## PLANNING COMMISSION AGENDA

Thursday, June 5, 2025

CITY OF DAYTON, MINNESOTA

Dayton Interchange Business Center, Preliminary Plat, Site Plan (Scannell)

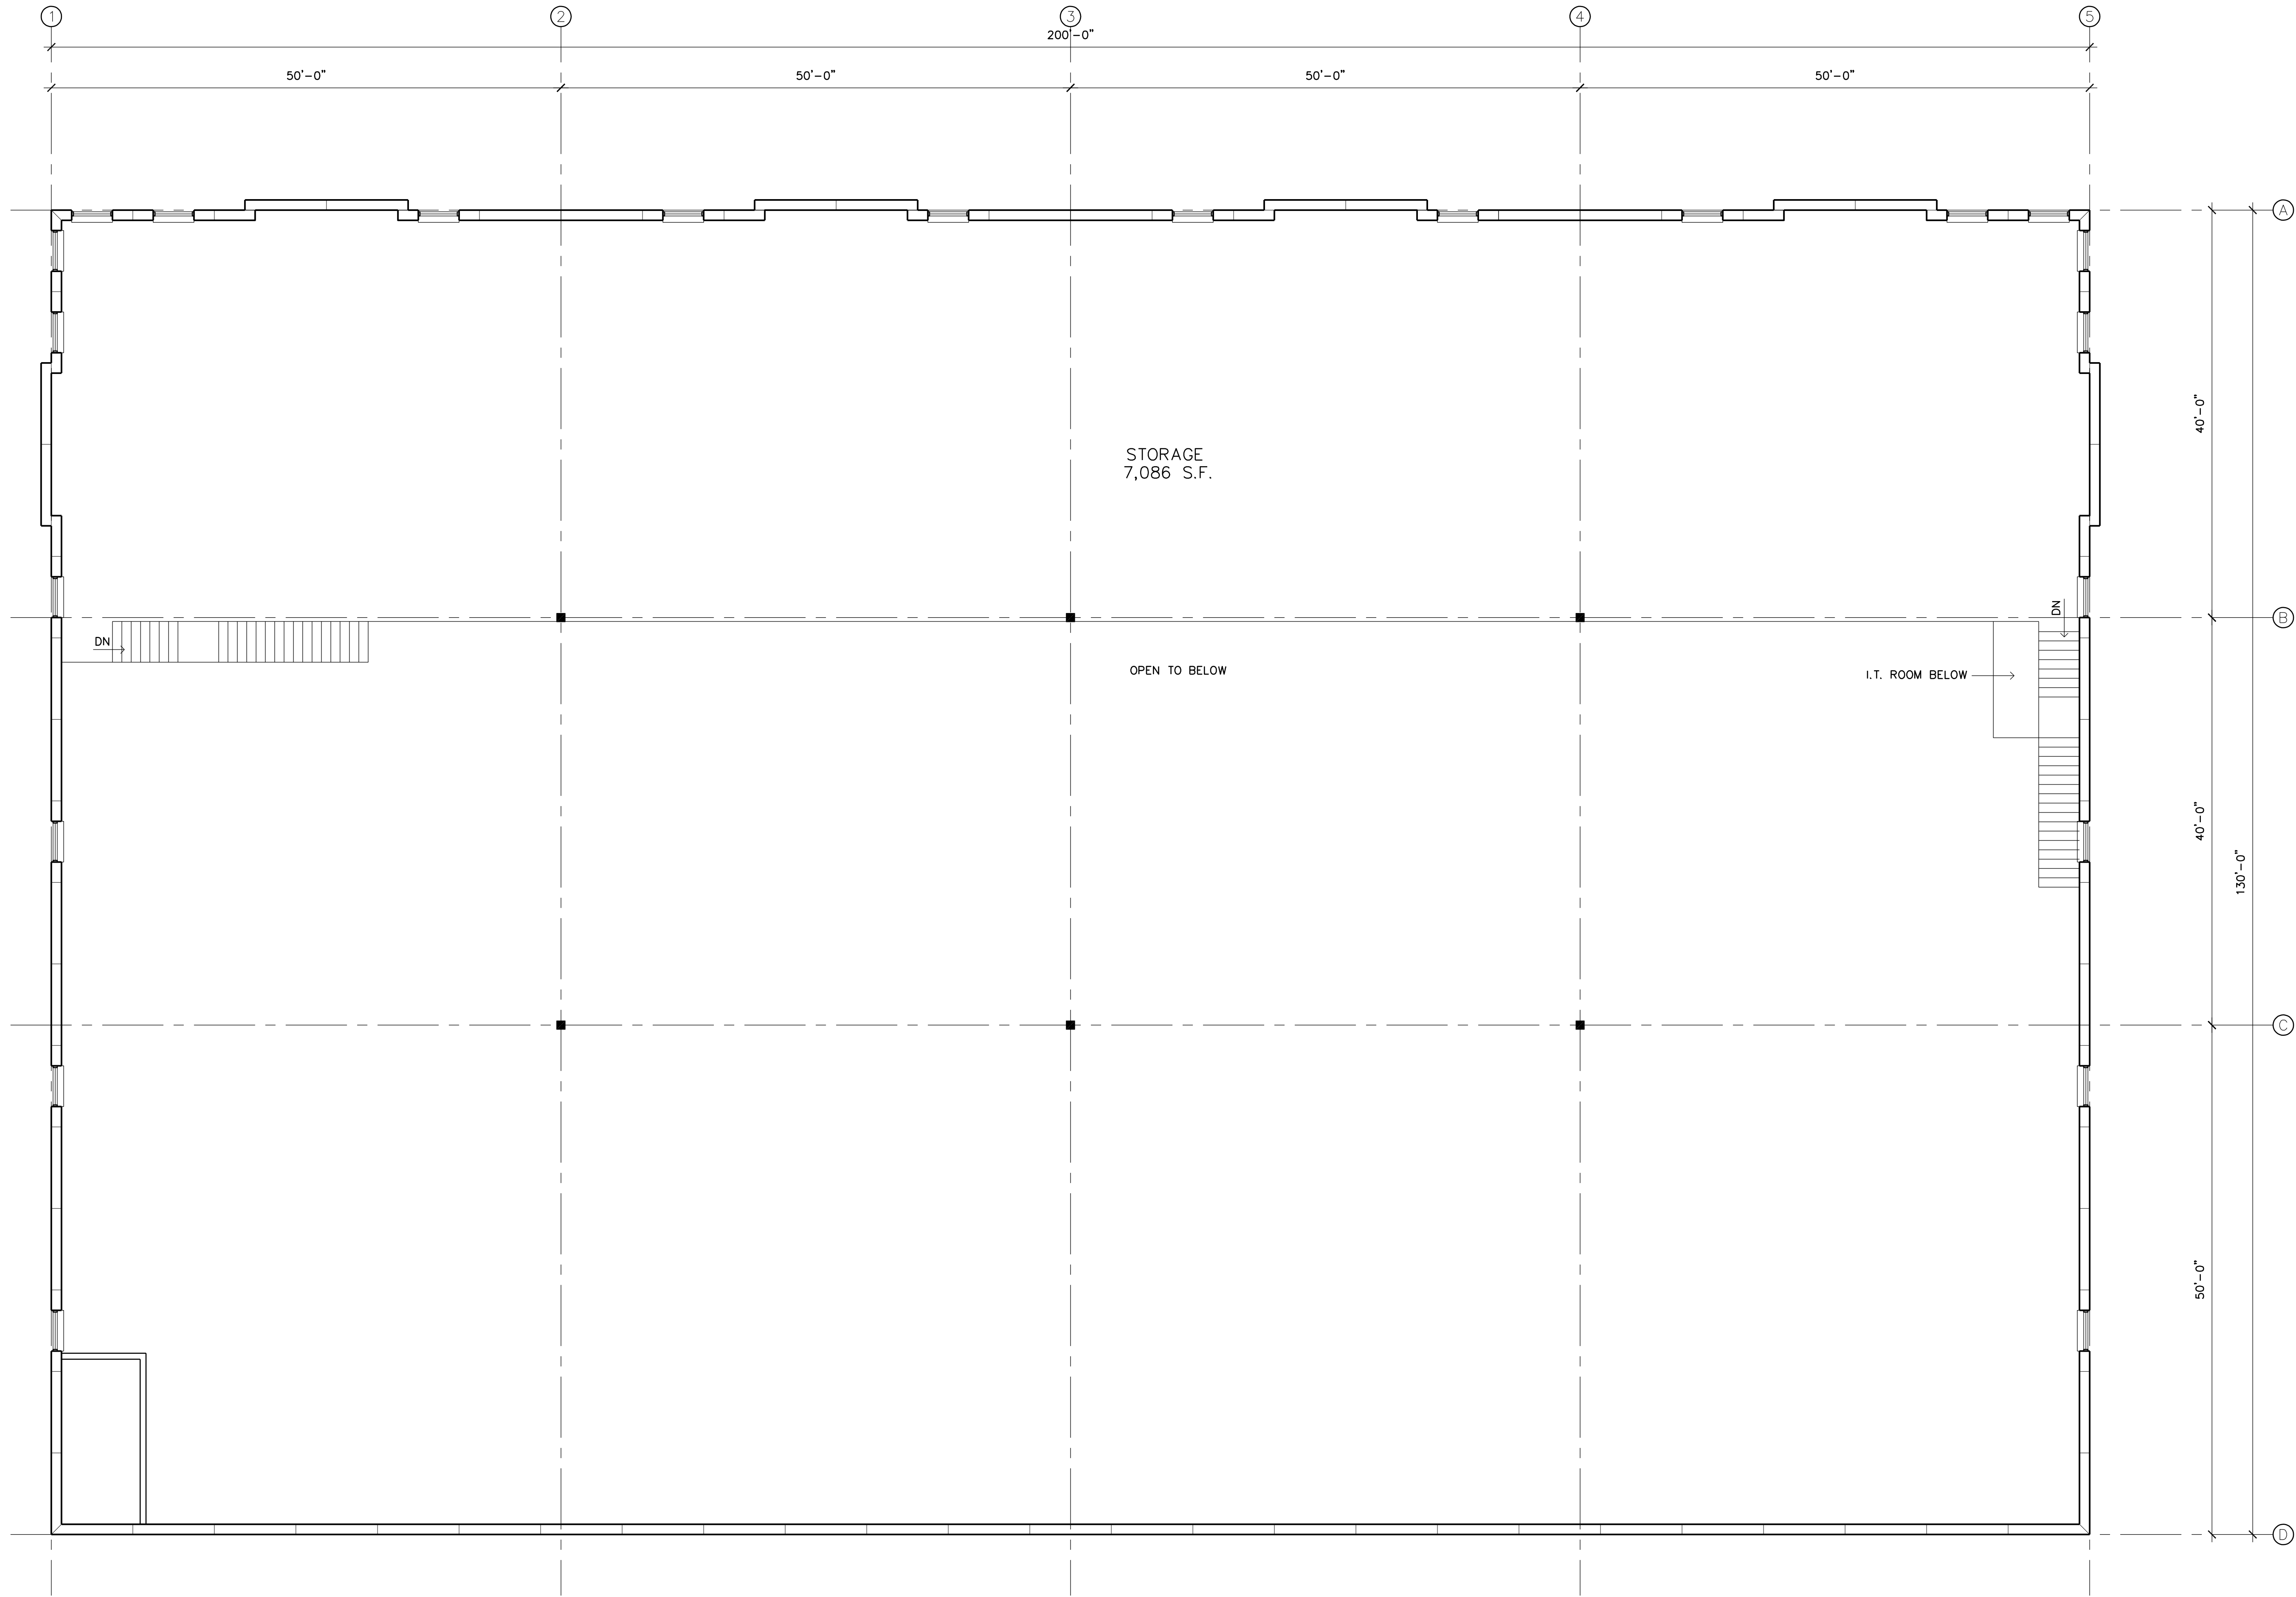
14. The total parking spaces on the concept plan is 77. Depending on the maximum number of non-office employees on a given shift, this number may be sufficient for meeting the parking requirements established in the Zoning Ordinance. This information shall be verified during the next round of applications.
15. Parking stall dimensions shall comply with the Zoning Ordinance standard of 10' x 20'. Parking stall length may be reduced to 18' if there is sufficient room for overhang.
16. Per the Zoning Ordinance, parking spaces shall not be located between the front façade line of the building and the street edge.
17. Parking rows shall be limited to a maximum length of 22 spaces. Longer rows shall include landscaped breaks, such as islands, with shade trees.

16. The proposed parking stall dimensions conflict with the standards laid out in the City of Dayton code.
17. The proposed entrance is to be built to the commercial driveway apron standard detail.

1 ELEVATION - SOUTH - OVERALL  
A300 3/64" = 1'-0"

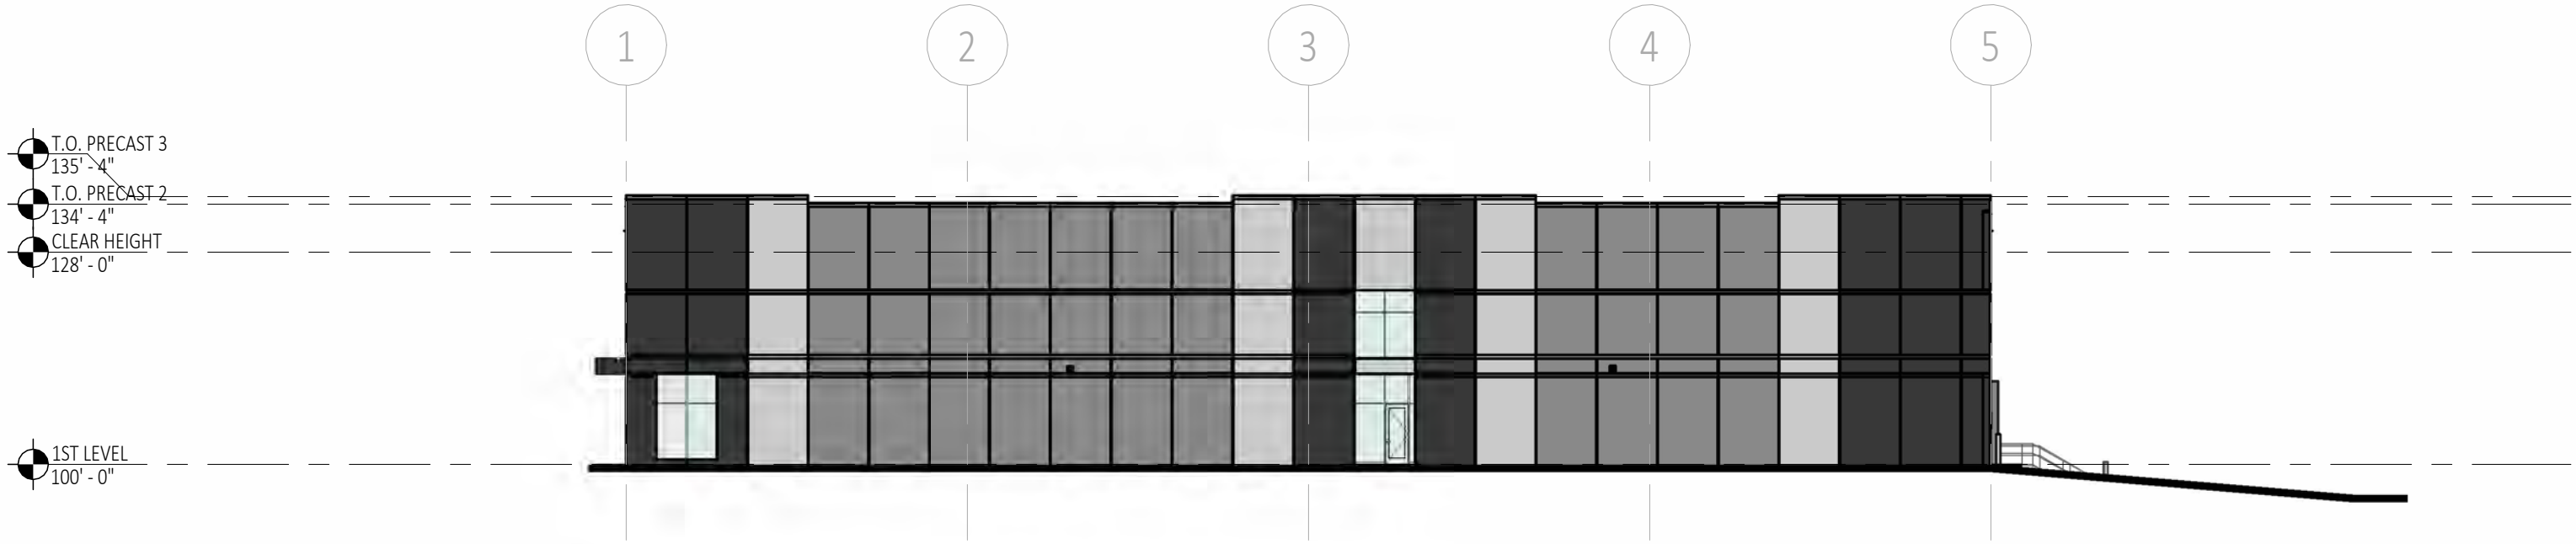
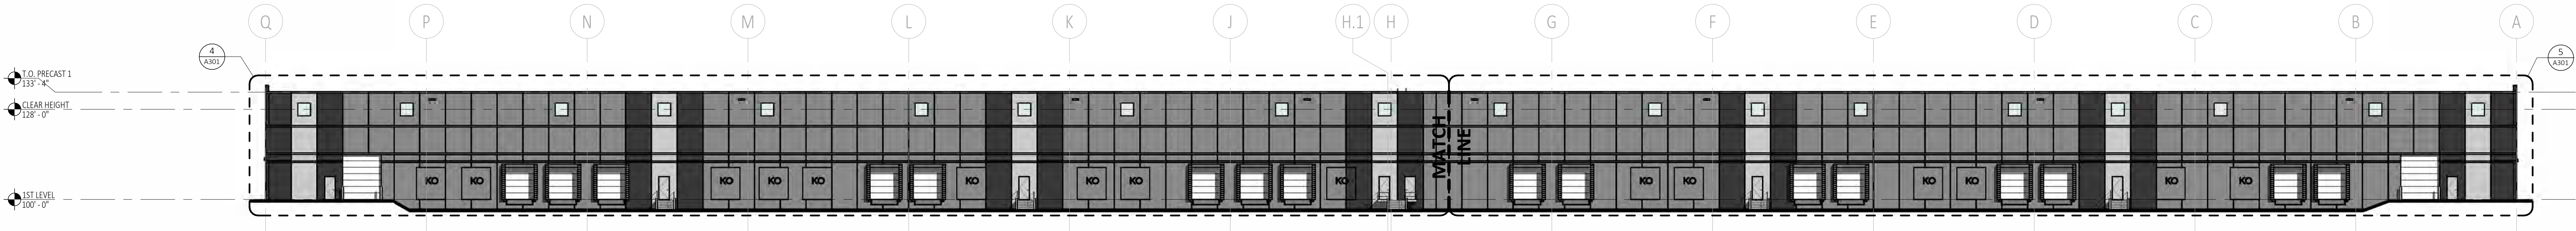
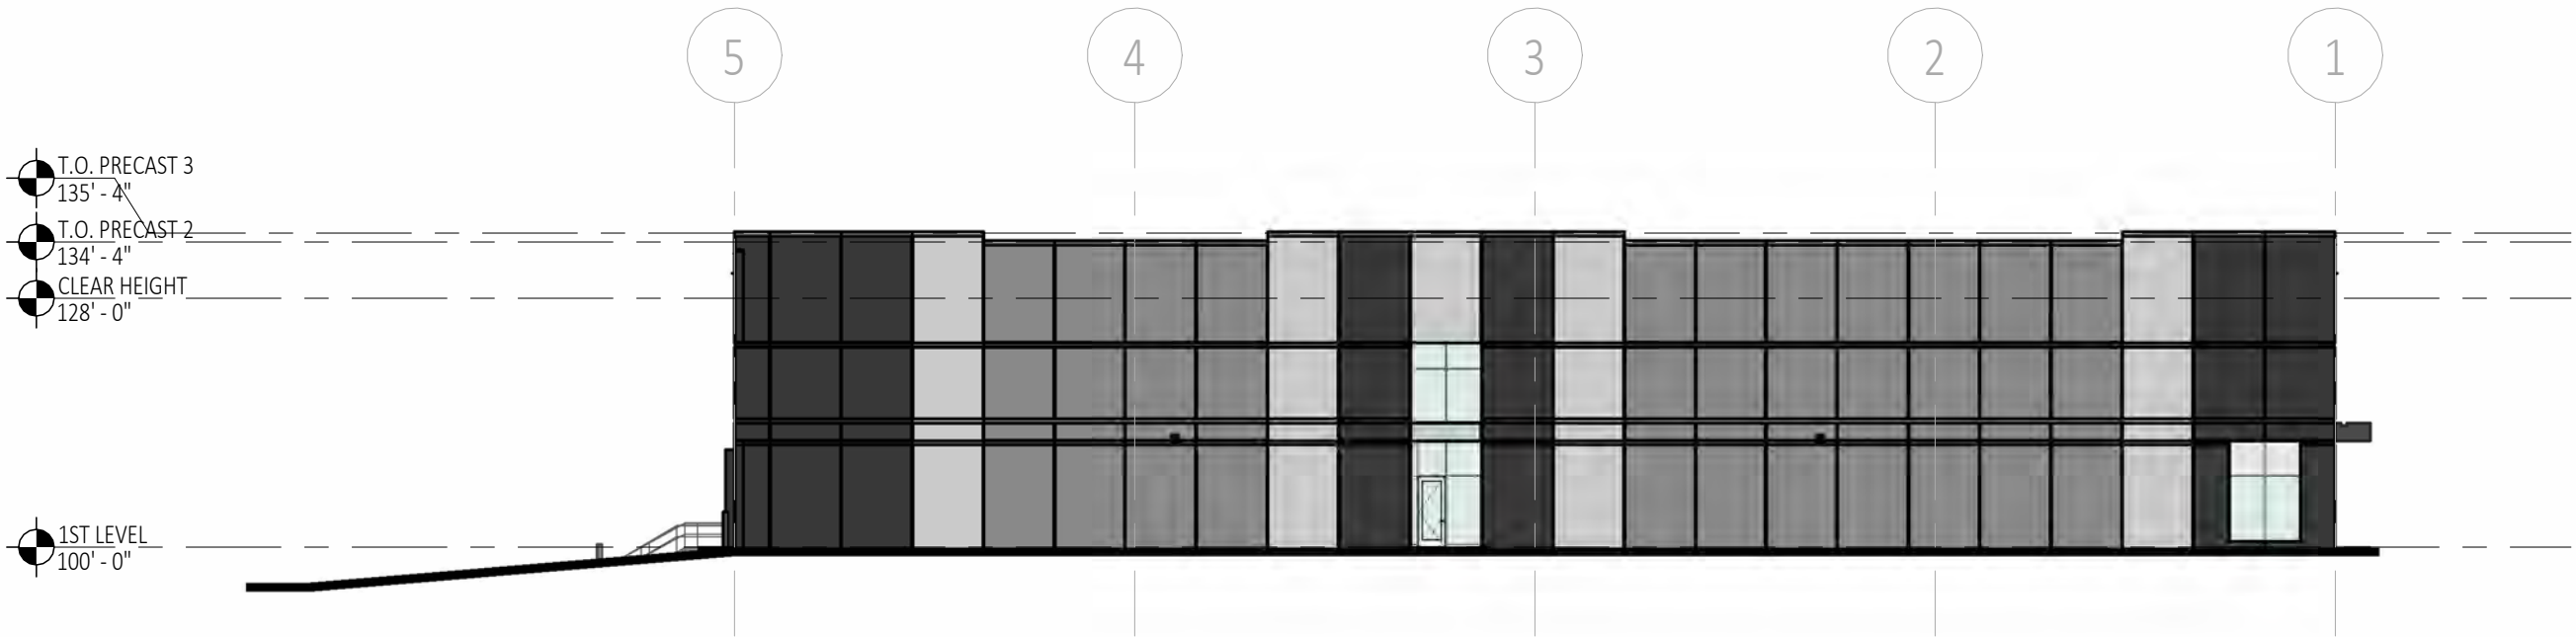
1. Building façade shall include minimum of 25% window coverage on each front that faces a street (e.g. Territorial Road), consistent with City Code 1001.062, Subd 1(a)(3). Building elevation plans shall detail the % of window coverage.
